PLANNING OBJECTION

Harmful Massing and Overbearing Impact

Plot 23, Lingards Fold · Effect upon No. 92 Lingards Road

Application	2026/91657
Affected property	No. 92 Lingards Road
Date	29 July 2026

Figure 3. Schematic only. An approximately 1 m uplift is equivalent to about 12% of an approximately 8.2 m approved elevation height. The percentage expresses the scale of the vertical displacement, not a 12% increase in building volume.

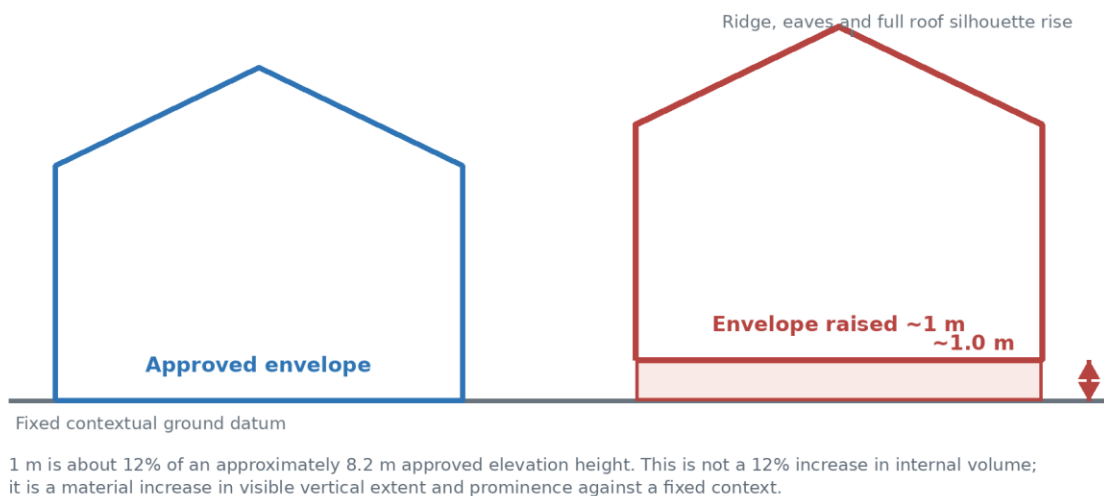
An upward displacement does not necessarily enlarge the internal volume of the principal house. It does, however, materially increase its apparent massing in the receiving environment. The entire building envelope—floors, windows, eaves, roof slopes and ridges—is presented approximately 1 m higher, and additional construction may be exposed beneath it.

If the surrounding ground remains unchanged, more of the building's vertical elevation is exposed. If garden or driveway levels are raised to meet the building, the ridge, eaves and complete roof silhouette still remain approximately 1 m higher and continue to obscure more sky than the approved scheme. The raised land, terraces or retaining works may also add further engineered bulk.

Why the uplift matters: The increase is not confined to a ridge point. The full breadth and depth of the dwelling are carried higher within the outlook from No. 92. This amplifies the visual effect of the wider garage wing, the roof planes and the building's already elevated relationship with the bungalow.

Figure 4. Bedroom 3. The completed form occupies much of the usable window opening and presents a broad, elevated frontage. The double garage extends the development farther across the outlook.

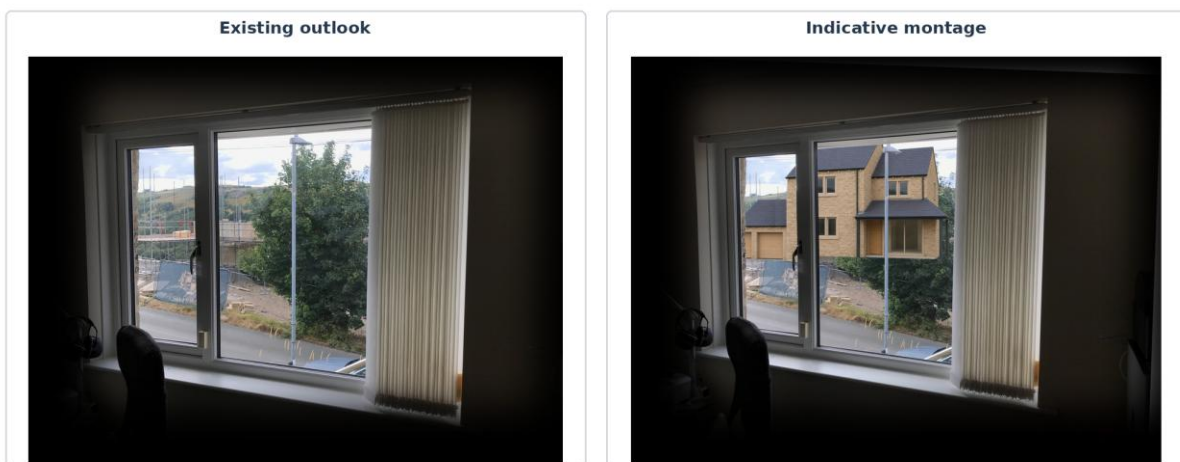
This view demonstrates horizontal massing particularly clearly. The building is not a peripheral feature within a wider landscape; it becomes the principal object in the window, with only fragmented openness remaining around it.

Figure 5. Lounge. The oblique viewpoint demonstrates depth, flank walling and the relationship between the principal roof forms. It confirms that the effect is a substantial three-dimensional volume, not simply a wide front elevation.

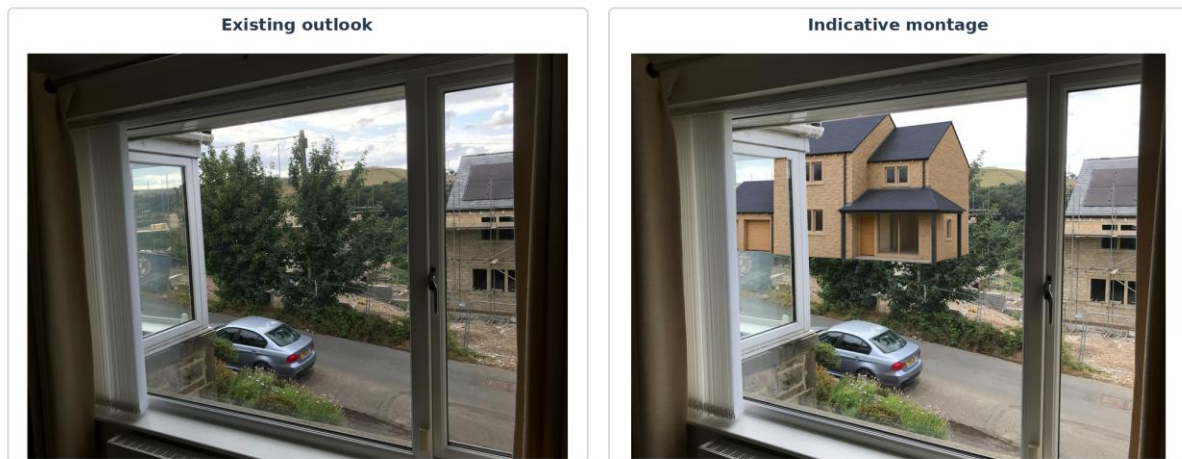
The lounge is the principal living space. The continuation of the effect into this room is important: visual dominance is experienced during ordinary daily use and is not limited to a secondary or infrequently used part of No. 92.

Figure 6. Bedroom 2. The more direct relationship shows the broad frontage and roof silhouette occupying a substantial proportion of the window and replacing open sky and longer-distance outlook with close built form.

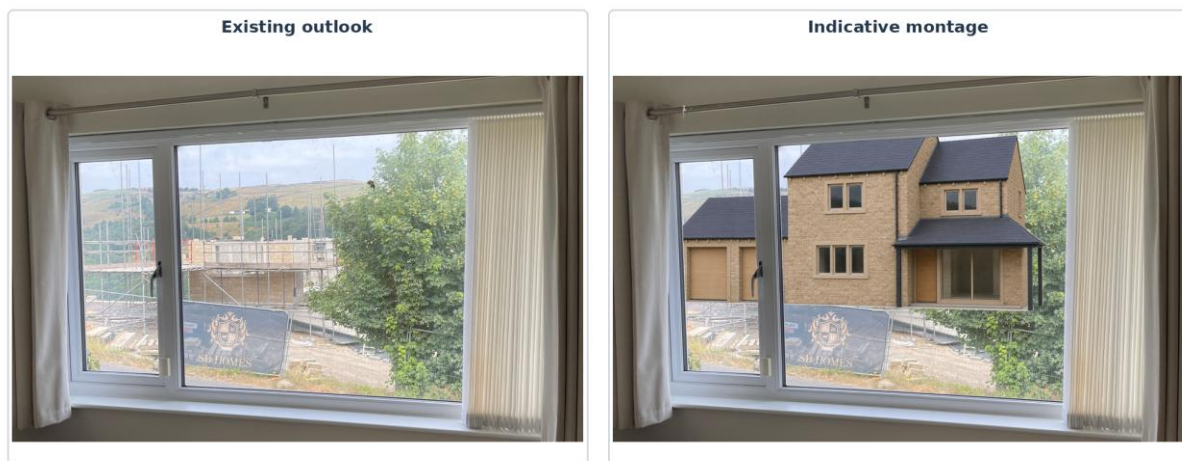
Bedroom 2 provides the clearest direct demonstration of enclosure. Considered with Bedroom 3 and the lounge, it shows a broad zone of visual influence across No. 92 rather than an isolated impact at one point.
